## Flood Control Project Maintenance Levee Inspections

### Fall 2020 Levee Maintenance Deficiency Summary Report

#### Sacramento River Basin

**Reclamation District No. 1000 Natomas**

Photo 1 of 1 : FA\_2020\_RD1000\_31\_10\_20201022\_00067.jpg

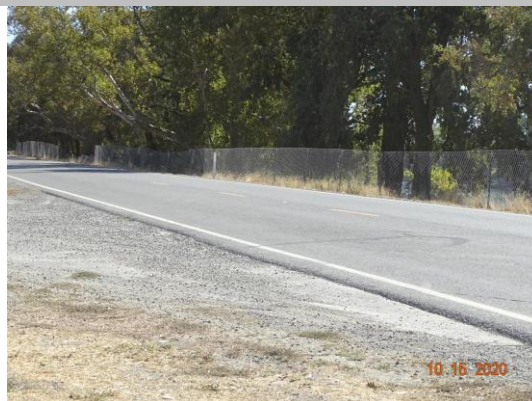
LM Start	9.09	Rating **	M	Issue No.	10
LM End	9.18	Issue Type +	En	Location *	WS
Category	Earthen Levee			GPS Latitude/Longitude	
				Start	End
Item	Encroachments			38.666650 °	38.665750 °
				-121.614461 °	-121.613078 °
DWR ID	DWR_RD1000_01_f_2017_10				
Comment Code					
FE : Fence					
Inspector Comment					
Non-permitted fence needs to be removed.

View on waterside of a non-permitted fence.

Photo 1 of 1 : FA\_2020\_RD1000\_31\_14\_20201022\_00079.jpg

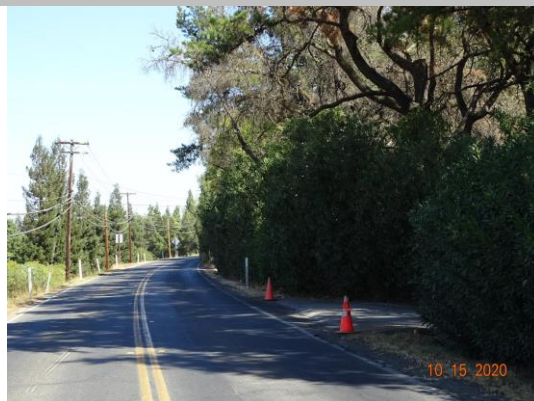
LM Start	16.68	Rating **	M	Issue No.	14
LM End	16.72	Issue Type +	En	Location *	WS
Category	Earthen Levee			GPS Latitude/Longitude	
				Start	End
Item	Encroachments			38.603242 °	38.603597 °
				-121.539318 °	-121.538875 °
DWR ID	DWR_RD1000_01_s_2012_14				
Comment Code					
FE : Fence					
Inspector Comment					
The vegetation needs to be removed from fence for visibility and access.

View on waterside looking across at the fence covered by vegetation.
